TO: Wheeler City Council
FROM: Bill Kabeiseman, City Attorney
SUBJECT: Planning File #2021-02-DR/0701-21-DR
DATE: July 15, 2022

LUBA remanded the City's decision denying an application for Design Review of a fish processing plant by Kenneth Ulbricht. LUBA found that the City's decision did not adequately explain its decision in the findings. The Council indicated that it did not want to reopen the hearing in the matter but, instead, evaluate the remanded findings and make a new determination based on the guidance from LUBA. This staff report identifies the six issues that were remanded from LUBA and, in each instance, provides the text of the code provision, the City's previous finding, and the discussion of that finding from LUBA's opinion. The Council should review the information in the staff report and provide direction to city staff to prepare a new decision on remand in this application.

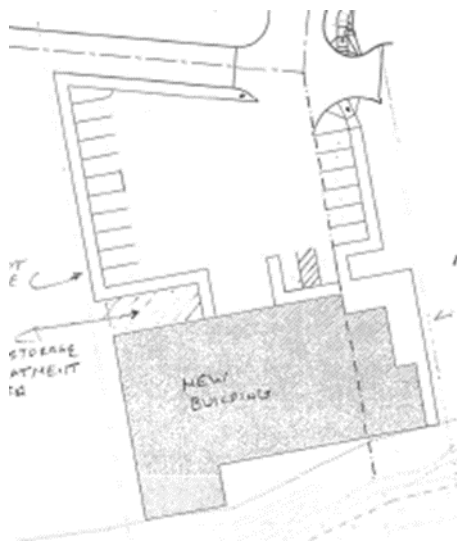
On this issue, LUBA agreed with the City that the site plan did not include sidewalks encircling the site. However, LUBA indicated that the findings were inadequate to adequately explain the extent of this requirement and how it might be satisfied. This City's option here would be to explain with greater detail how the building orientation and parking violates the pedestrian circulation obligations or otherwise find that what is proposed satisfies the standard.

To provide further elaboration on the existing findings, the Council might emphasize that the need for pedestrian connectivity extends beyond just the street but includes off-street parking area, as an activity occurring on the site that must maintain a direct connection with the parking serves. The connection between off-street parking and the building entrances for that use must be "direct" and cannot be intercepted by other activities. A "direct pedestrian connection" is one that allows pedestrians safe access to buildings and to other activities. As proposed, the loading docks accommodating maneuvering trucks and forklift traffic will leave patrons and employees with no safe, direct, connection to the building. Further, of the 9.5 spaces required to serve the retail space, at least 2 of them will be located on the north side of the lot and require crossing the truck loading area. Rec 12 and 67. Asking retail customers, who may well be tourists new to the area, to traverse an active industrial loading area on foot only exacerbates the safety concerns.

A design that satisfies this requirement would relocate the truck loading area so that it does not block direct pedestrian access from the customer / employee parking area into the primary retail and industrial pedestrian access points. To do this, the truck loading and maneuvering area must be relocated outside of the center of the parking lot serving visitors and employees, perhaps on the north side of the site. This change would allow for direct pedestrian access along protected sidewalks into the retail and industrial building entrances located further to the south. Without providing the requisite direct pedestrian connection, the Council could find that WZO 11.050(4)(a)(6) is not satisfied.

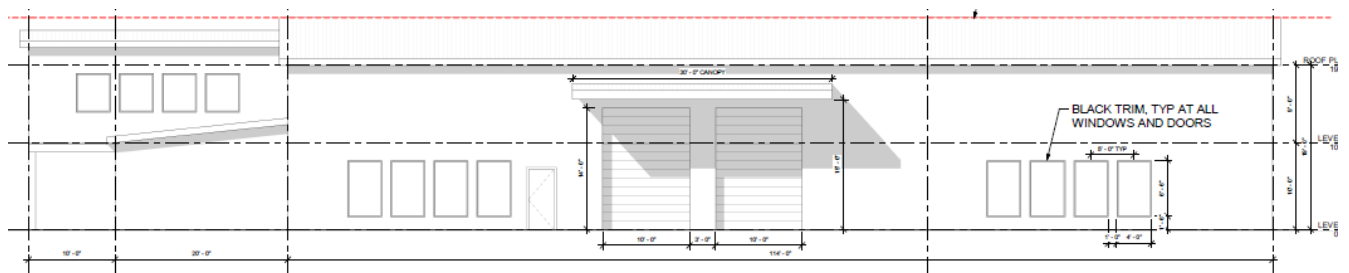
The city council does not explain the source of its definition of "monotony," but Webster's defines it as "sameness that produces boredom" and "sameness or uniformity of tone or sound * * *." *Webster's Third New Int'l Dictionary* 1464 (unabridged ed 2002). The city council found specifically that "[t]he north and west elevations show nothing but the similar patterns of windows amidst gray/black metal siding and a single door. The Council finds the north and west elevations are particularly monotonous and lack detail." Record 15. We find the adequacy of this finding to be the closest call. Although petitioner argues that there is a canopy over the entrance on the north side, the canopy detail shown on the elevation appears minimal and the roofline variations are less varied on the north and west sides of the building. Record 99. We agree, however, with petitioner that the city's findings are inadequate to explain why the detail, form and site design proposed by petitioner are inadequate to demonstrate that the proposed design satisfies this criterion. The criterion is focused on avoidance of monotony of design in a building project," and the findings do not explain whether the criterion requires evaluation of monotony on an elevation by elevation basis, as opposed to the building as a whole. The criterion includes no measuring points, no description of what is necessary to demonstrate a "variety" of detail, form, and site design, and no description of what is meant by "visual interest." If the city desires to have a certain amount of wood versus metal, or a certain number of colors used, or other features that, in the city's view, "avoid monotony," the city is obligated to inform petitioner, in the words of *Commonwealth [Properties v. Washington County, 35 Or App 387, 400, 582 P2d 1384 (1978)]* specifically how those policies will be applicable to the project in question." We also agree with petitioner that the city's findings regarding this criterion are inconsistent with other findings that point out that the retail sales portion of the building has "distinct roof separation and exterior finish" and

that "improvements on the industrial portion of the site effectively break up the monotony of a blank wall." Record 16-17. On remand, the city must specify what is lacking in petitioner's proposal to meet the required "variety of detail, form and site design," and what is meant by "visual interest."

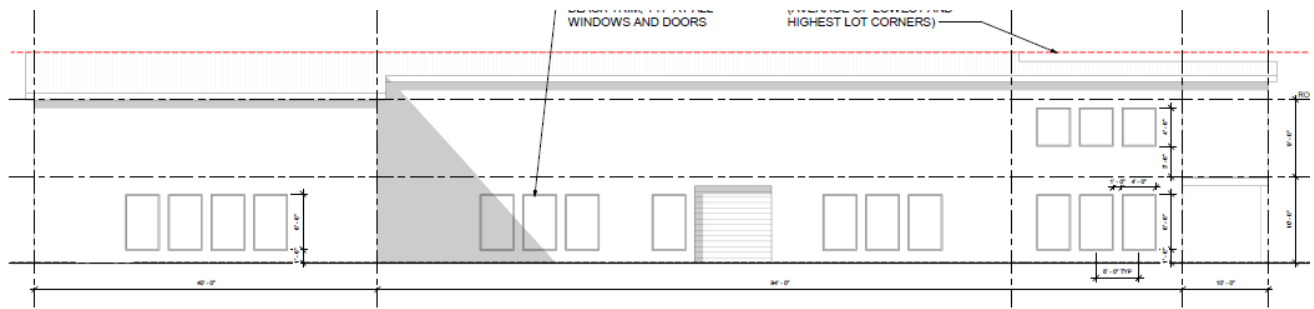
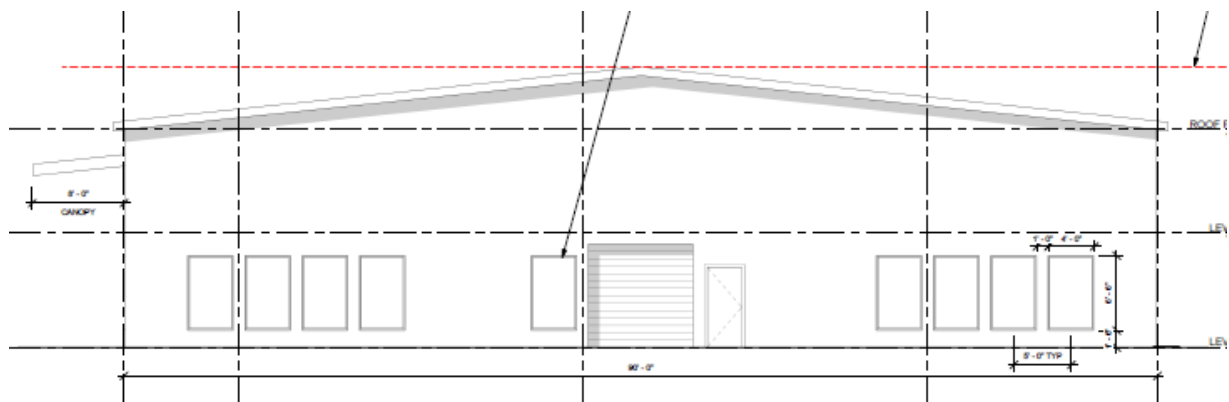
As depicted in this drawing, the left side of the west elevation provides a building recess, change in roof line, window size and location at approximately 30' of the total 144' building length. Although the location of the canopy and wood cladding surrounding the loading bays within the remaining linear frontage is not known but at 30' wide, this leaves a remaining 84' without any change. In order to satisfy a rough 25% change rule, there would need to be another change of roof line, recess, window size or location or order to break up the monotony on this elevation.

The west elevations suffers from the same shortcoming in that there is a lack of variety for the center portion of the building or for 94' linear feet. This area would need to be broken up with an additional recess, change in roof line, materials, window size or placement to provide the necessary variety.

Of the four elevations, the north elevation lacks any variety and would need to be substantially revised. It is important to point out that using this 25% of an elevation frontage to trigger a change in detail, form and site design is general and if mechanically applied, could similarly create a monotonous design. This standard should be not viewed as one that is necessary clear and objective. Rather, overall architectural style, use, and surrounding context might dictate changes in details that deviate from this approach. That said, unchanged details for expanses of 84' feet on the east elevation, 90' on the west elevation and the full 90' on the north elevation results in a lack of design variety sufficient to satisfy WZO 11.050(4)(b)(3).

Taking an elevation-by-elevation approach, the findings discussing WZO 11.050(4)(b)(10) did conclude that the inclusion of windows on the industrial side of the building were sufficient to "break up the monotony of a blank wall" but the Council may find that WZO 11.050(4)(b)(3) requires a greater degree of design variety than simply breaking up a blank wall. Rather, the requisite "variety" will include changes in detail, form and site design such as recessed building facades, changes in roof line, variety in window sizes or materials. The Council might agree that the south elevation, with the overhanging roof, shed roof covered first-story bump out, different windows and use of wood siding is sufficient to avoid monotony. If that is the case and taking the 25% replication reference as a guide, the Council might find that a change in roof line, wall recess, materials, window size and placement for every quarter of linear length of an elevation.
